Architectural Review Board

January 22, 2019
Council Auditorium, City Hall
103 North Perry Street

SUBJECT: Request for approval of a rear yard fence and gate for the property located at 123 South Capitol Parkway (Capitol Parkway-Capitol Heights).

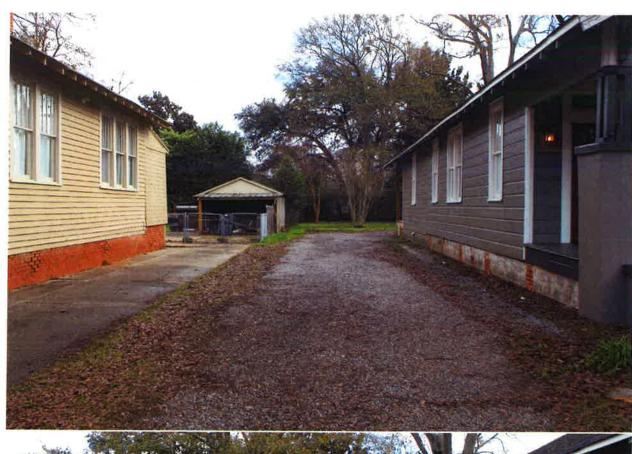
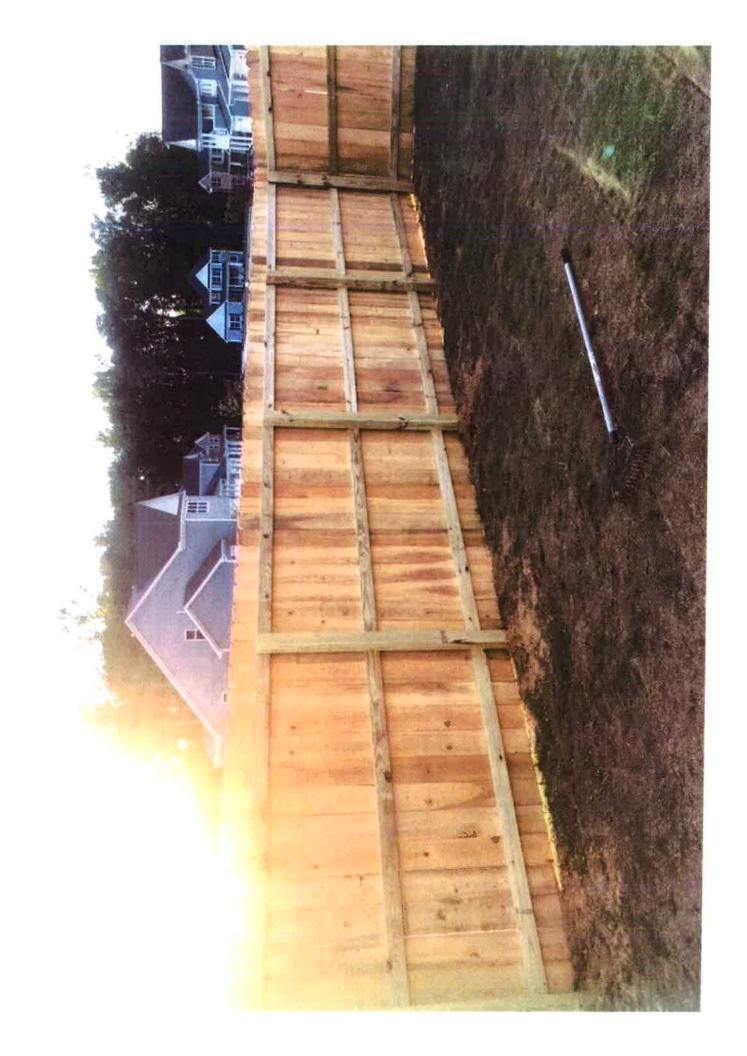
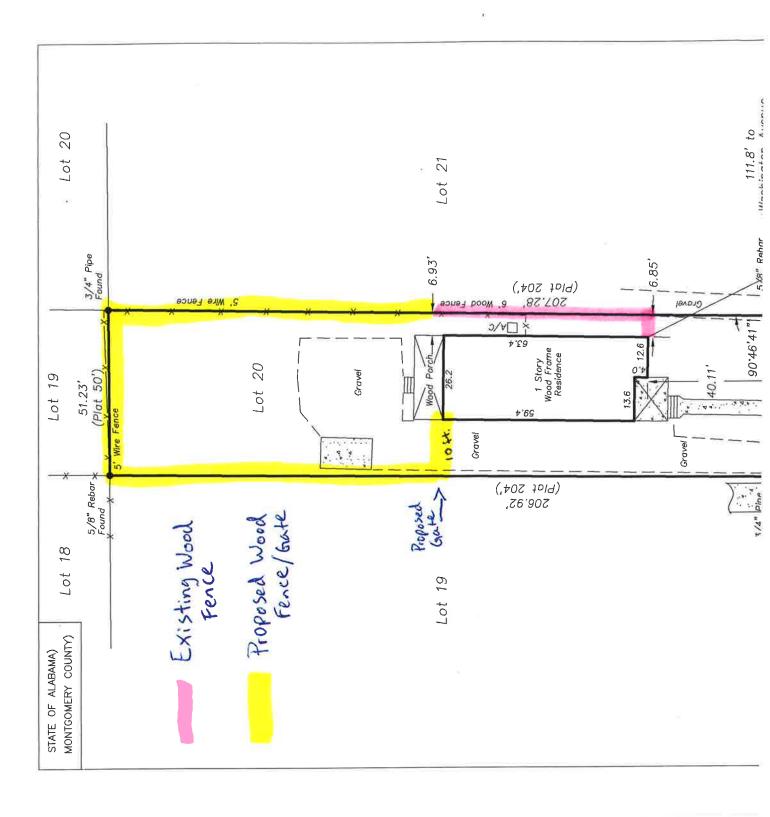
REMARKS: The petitioner is requesting permission to install a 6' dog eared cypress rear yard fence that matches existing sections of wood fence on the south side yard. Fence will replace existing chain link fence and enclose the rear yard with a matching gate at the rear corner of the house.

The Board has routinely approved rear yard privacy fences.
